Interactive comment on “Hydraulic modelling of drinking water treatment plant operations” by G. I. M. Worm et al.

Response on review of DWESD 1, 155–172, 2008: DWESD 2, S3–S5, 2009

Fig. 2. (NB. this will be fig 3 in the revised paper). Validation of flows from wells.

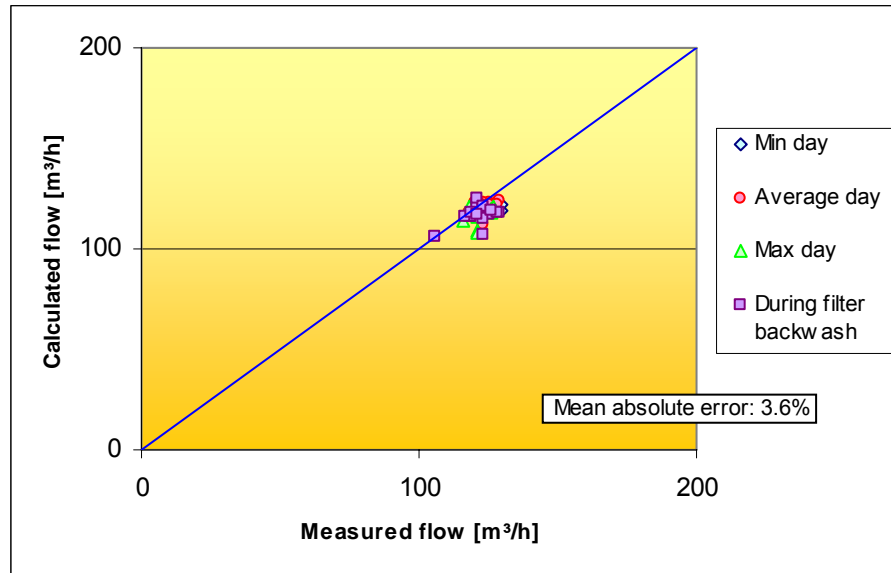
Q: Independently from scale, the plots in Figures 2 and 5 show some obvious deviations. In Figure 2, measured flows from wells are mainly bigger than calculated. On the other hand, in Figure 5 almost all measured effluent flows in the rapid sand filters seem to be smaller than the calculated ones. In fact, only 3 measures are bigger than calculated flows. The updated figures shown in the reply by authors seem to be mistaken, since the three figures are the same.

A: The right, different, figures have been sent to the Publisher in response to the comments of the first referee, but during typesetting one figure was copied three times. Again the three new figures are given below and hopefully will end up in the typ set of this reply. From the reply to referee 1:
